HAMS Fashion Ltd

Dakkhin Vanganahati, Sreepur, Gazipur-1740.
(24.193231N, 90.457894E)
28th January 2019

Observations

Apparent lack of lateral stability

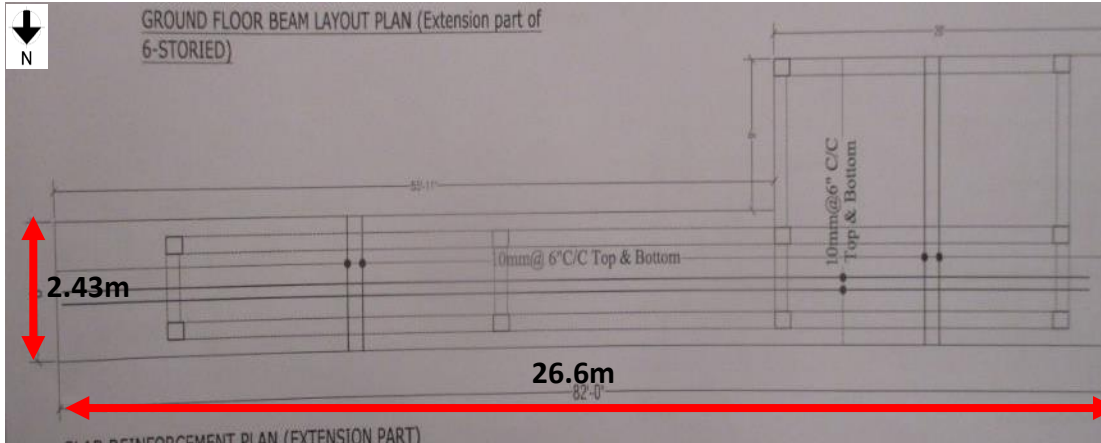
Factory engineer to check lateral stability of the building against lateral load combination for poor aspect ratio. The structural arrangement in tall slender building (ht-11.3m) may result in net tension in structural element.

Implement floor load management program

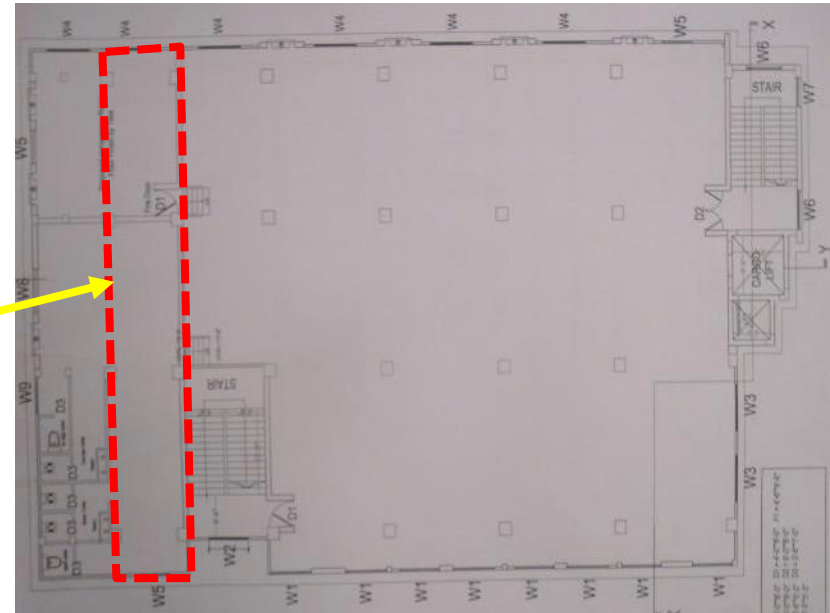
Most of floors were not occupied till the inspection day. Factory is required to maintain floor live load plan and implement load management program (posting the load plan & load height restriction signage) as per its floor loading capacity (5kPa) after occupying the floors. Follow the load plans for all floors and make sure that the workers understand the loading requirements.

Lack of information in As-built drawing

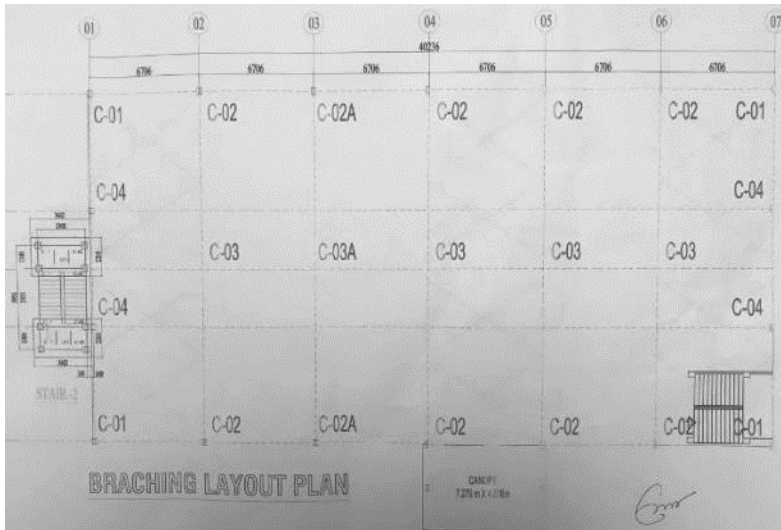
Different height floor slab with beam was observed on 1st floor but no detail was found in as-built drawing. Factory is required to update the as-built drawing to show the elevation difference.

Corrosion observed at steel sections

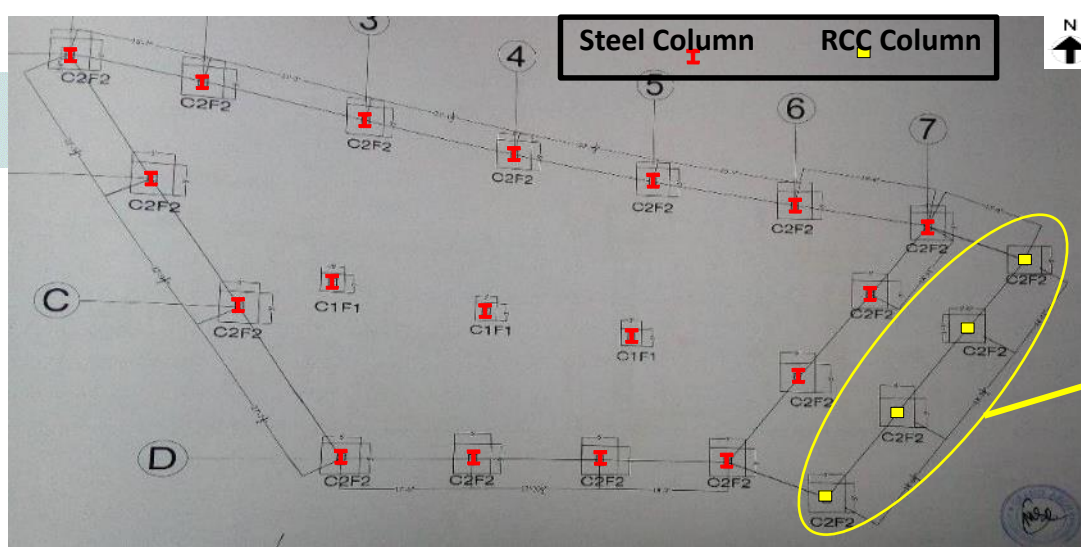
Corrosion was observed at beam-column joint of steel members. Corrosion was observed on the bottom part of ground floor column. Most of the corroded steel members were found under the toilet area. Factory is required to identify all the corroded locations and take proper remedial measures.

Discrepancies between as-built drawings and on-site observation

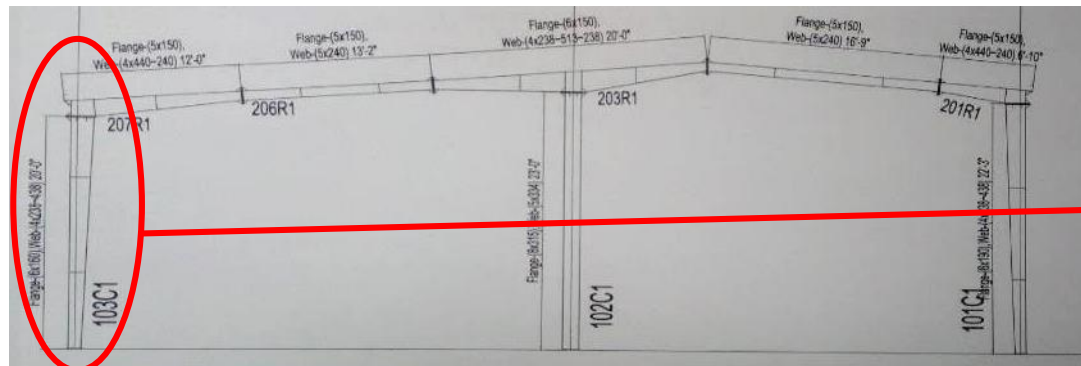
On east side, RCC columns were found instead of steel columns. In addition, no frame section detail was found for the east side. On south side, the column was found as uniformed section (F-160mm x W-340mm) instead of tapered section and the dimension of north side was found (F-160mm x W- 300~360mm) instead on (F-190mm x W-238~438mm).

Lack of information in As-built drawing

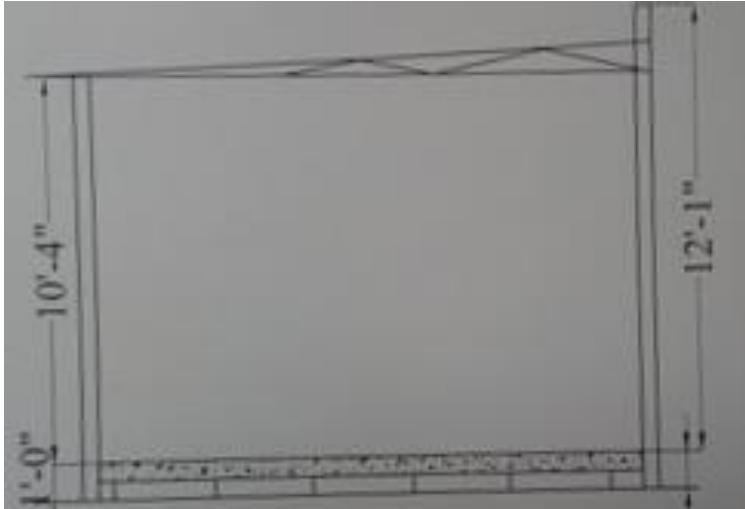
No detail of internal frame system was found in as-built drawing. Factory is required to update the as-built drawing to show the detail of internal frame.

Discrepancies between as-built drawings and on-site observation

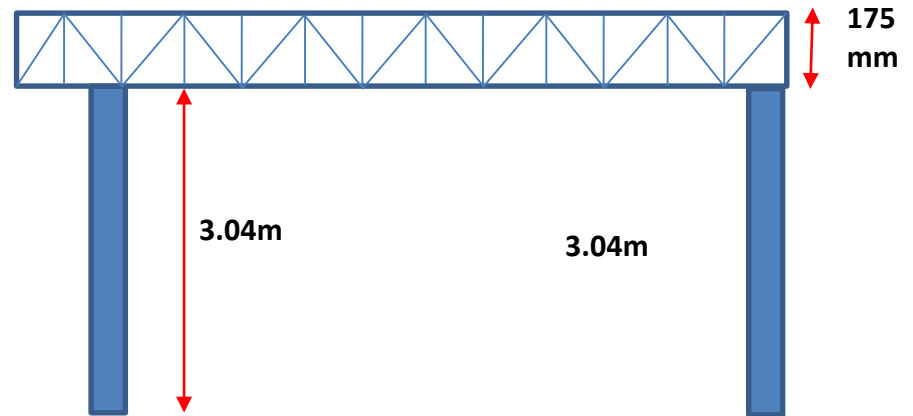
The internal framing system did not match with on site condition. Factory is required to revise the as-built drawing which reflecting the on site condition.
